Board of Zoning Appeals & City Planning Commission Agenda Via Video and Audio Conference Due to COVID-19 Public Health Emergency Tuesday, October 6, 2020, 7:00PM

#2077. 3570 WARRENSVILLE, LLC - 3570 WARRENSVILLE CENTER ROAD:

**Board of Zoning Appeals & City Planning Commission Minutes
Tuesday, September 1, 2020
7 P.M.**

SITE PLAN
 SCALE: 1/16" = 1'-0"

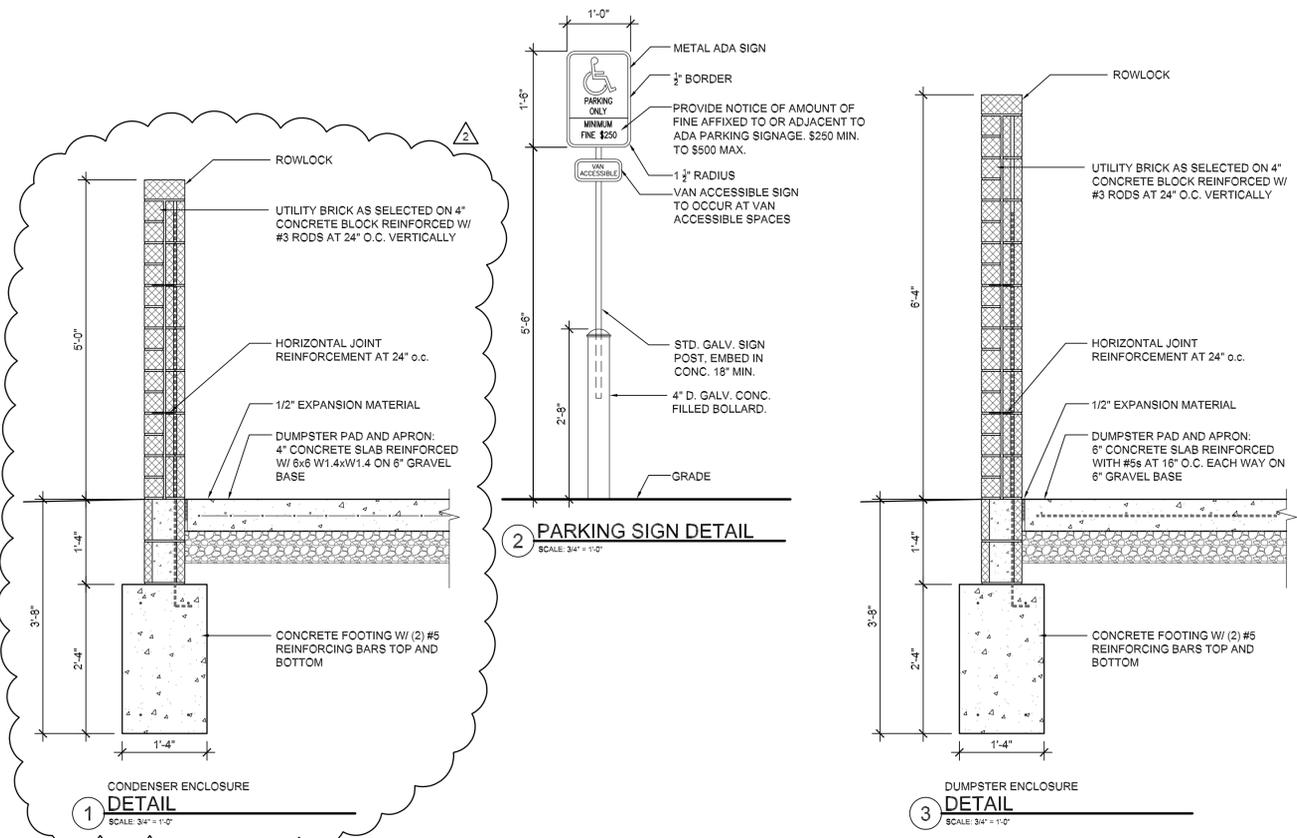
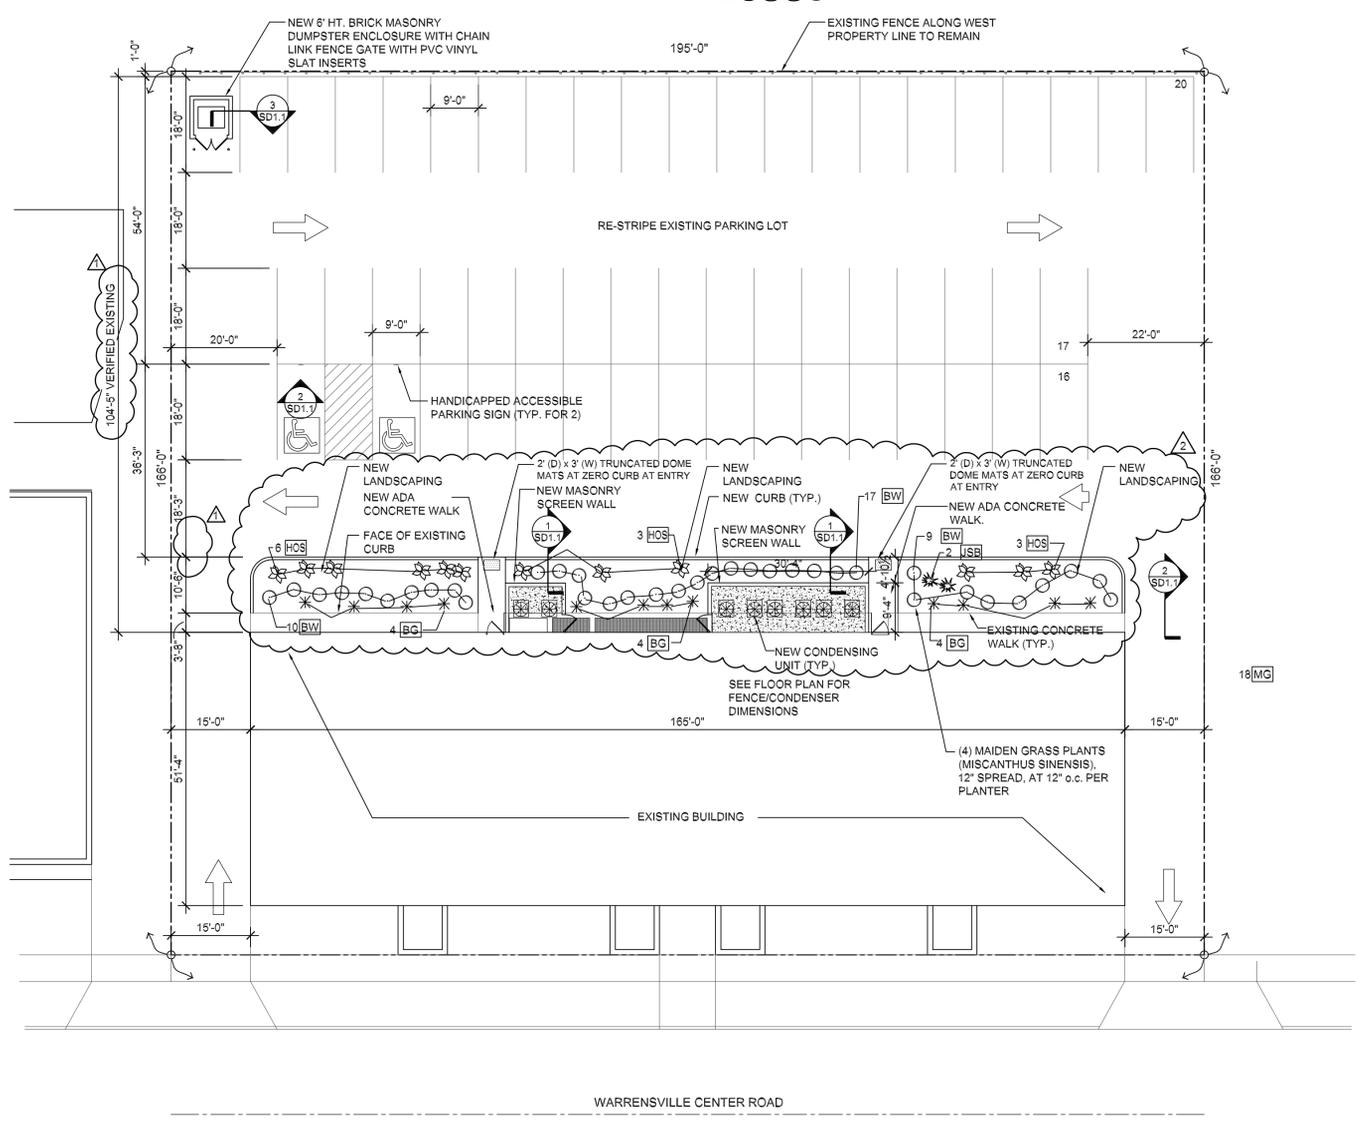
- A vinyl fence and planters are not an appropriate screen nor aesthetic treatment for the building.
- Investigate a continuous curb, evergreen landscaping and screen wall system for the rear of the building that is aesthetically appropriate for this commercial property and complies with building code regulations.

- A vinyl fence and planters are not an appropriate screen nor aesthetic treatment for the building.
- Investigate a continuous curb, evergreen landscaping and screen wall system for the rear of the building that is aesthetically appropriate for this commercial property and also complies with building code regulations.

1. Cut sheets and specifications for all the condenser units, including noise rating.
2. Site Plan, including, but not limited to:
 - a. Fence location noted on a site plan and expanded site plan, to scale, detailing the parking lot layout and drive aisle width, and
 - b. Verification of sufficient room around the units to install the fence without encroaching on the parking lot drive aisle.
3. Sufficient resolution of the City's enforcement action.
4. Completed Building Code review and approval of professionally prepared plans, including plans examiner approval.

1. Letter of request and explanation of how the original conditions of continuance have been met and how the proposal has changed plus explanation of the requested variances. This should include a detail of how the standards for a variance are met per code Section 1213.04 E.
2. The aisle width of the first drive aisle of the parking lot is less than the code required 22 ft. for a two way aisle. You will need to apply for a variance for that condition and explain in the letter.
3. Only one a/c condenser spec is provided. Are the existing units all being replaced with this one? Currently there are several different units on site.
4. Is the vinyl fence to be white? No color is noted.

1. **Response:** See response below for the Standards of Variance response.
2. **Response:** Proposed aisle width is greater than 22' on revised drawing a variance will not be required.
3. **Response:** The condenser spec provided is applicable to all condenser units.
4. **Response:** Proposed color for the fence is white.

Response: Variance is being requested to allow for the placement of HVAC condenser units along the west side of the building. The pitched roof of the existing building prohibits the equipment being placed there. The location along the west side of the building is also a much safer location for the condensers to be serviced.

PARTIAL PROPOSED FIRST FLOOR PLAN
SCALE: 1/8" = 1'-0"

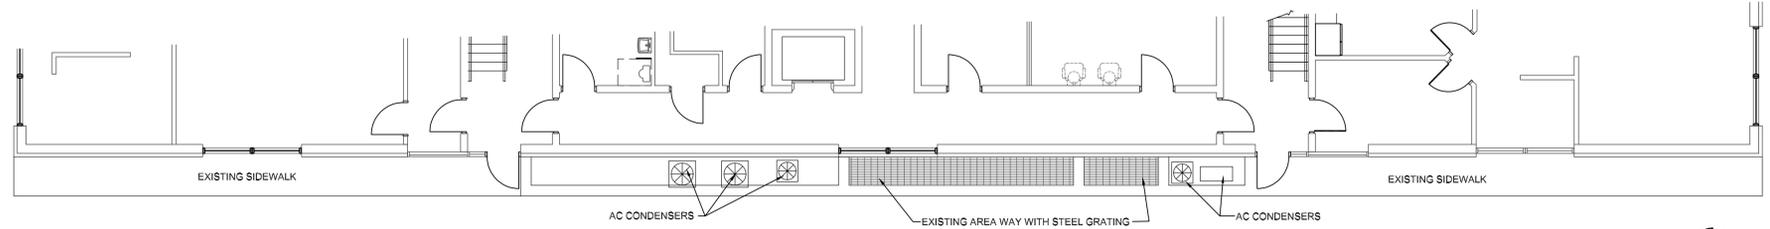
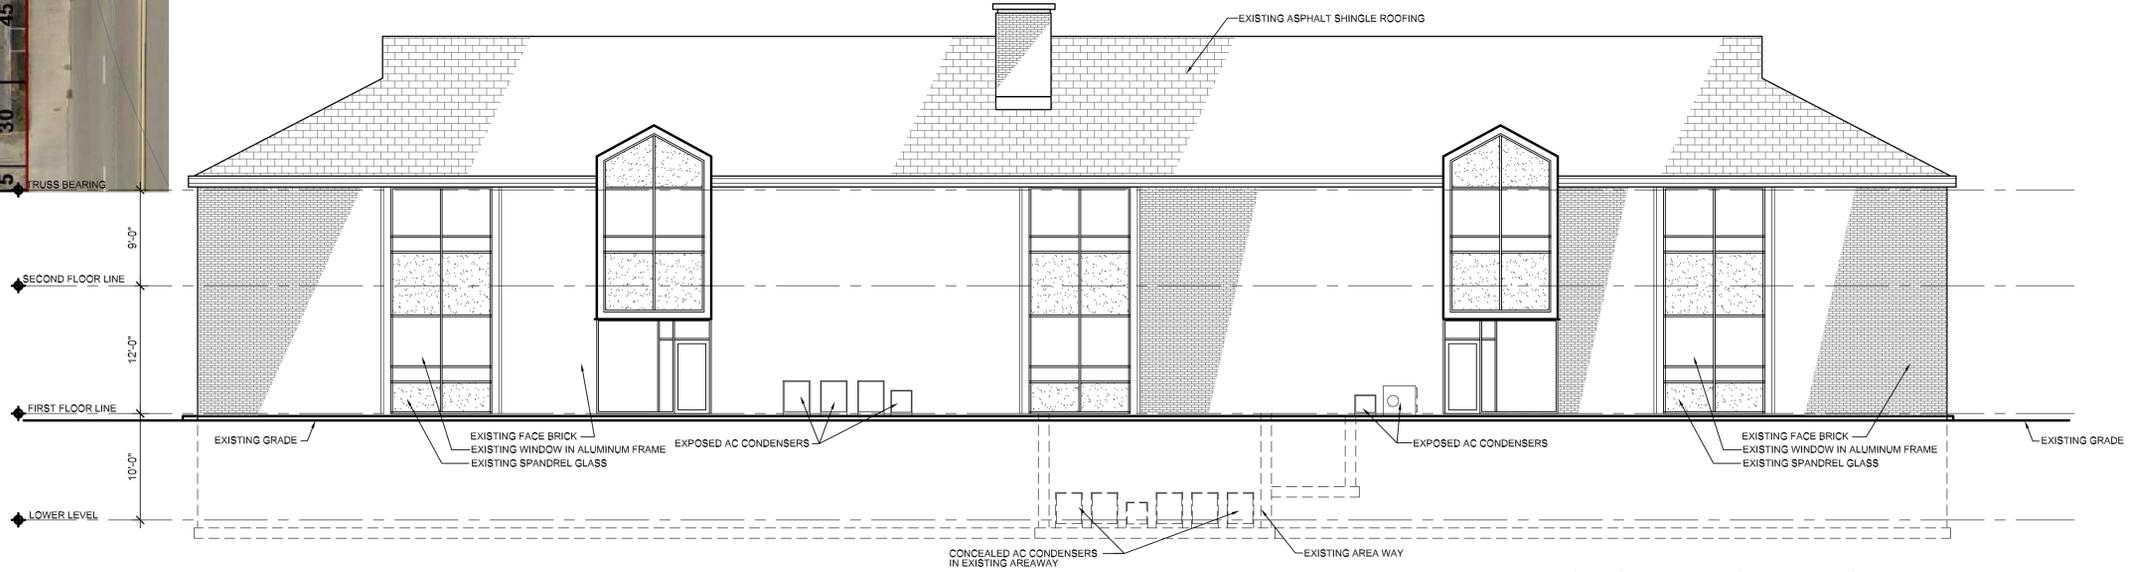
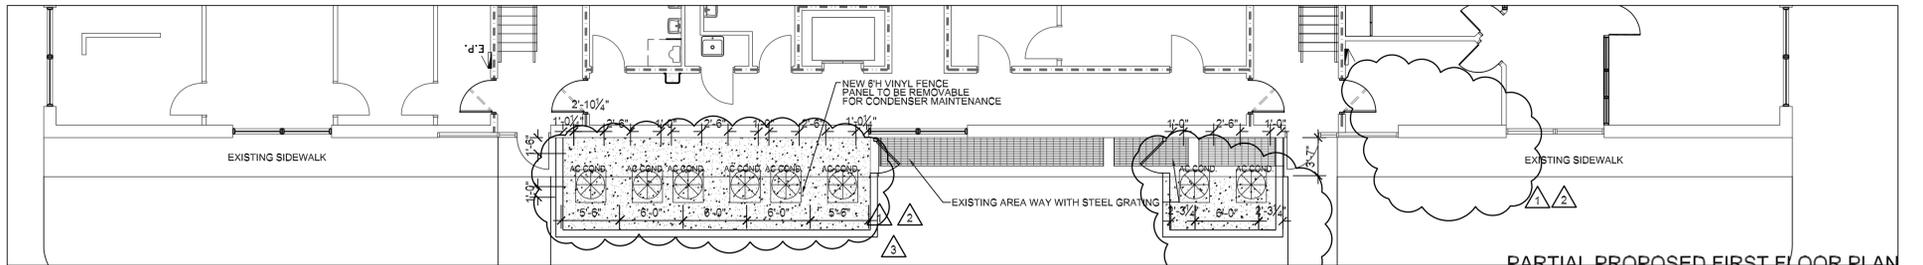
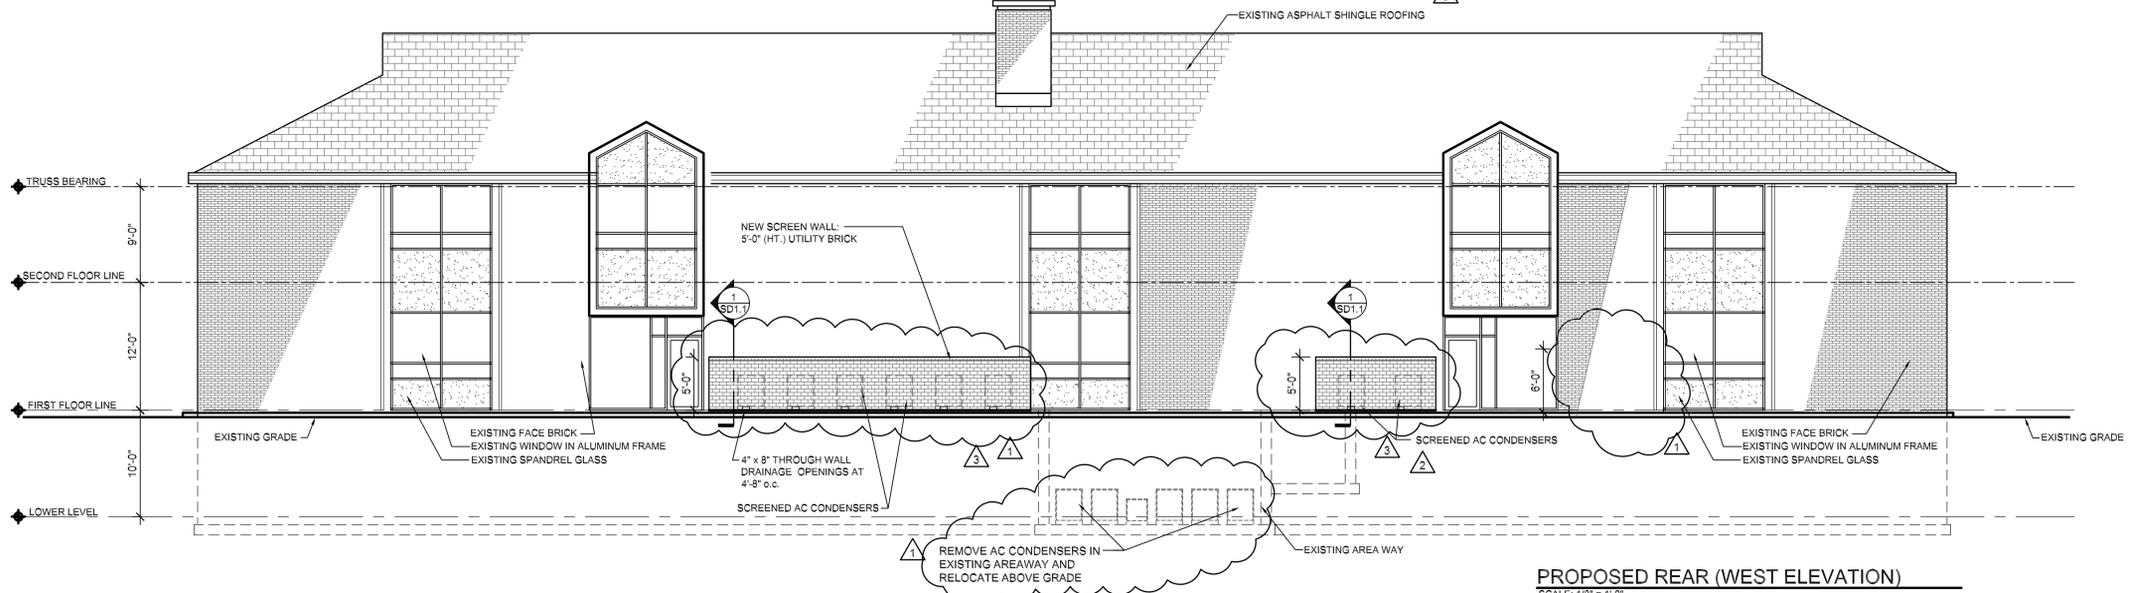
Mr. Boyle said planters are a poor way to install landscaping. The fence seems to screen the whole back of the building and entries in a material that does not relate to this brick commercial building. This is not an appropriate design for the rear of this building.

Mr. Dreyfuss-Wells agrees with others comments about the current screen plan. They should remove pavement and alter parking configuration if we are to consider exterior condensers. Planters are not a good option as it is hard to keep plants alive. This is not appropriate fencing. A more substantial screen is needed before the request should be considered again.

Mr. Dreyfuss-Wells said gates on the ends of any enclosure would aid maintenance and they may need more space so they should consider pushing them further from the building. Change the layout of the parking lot.
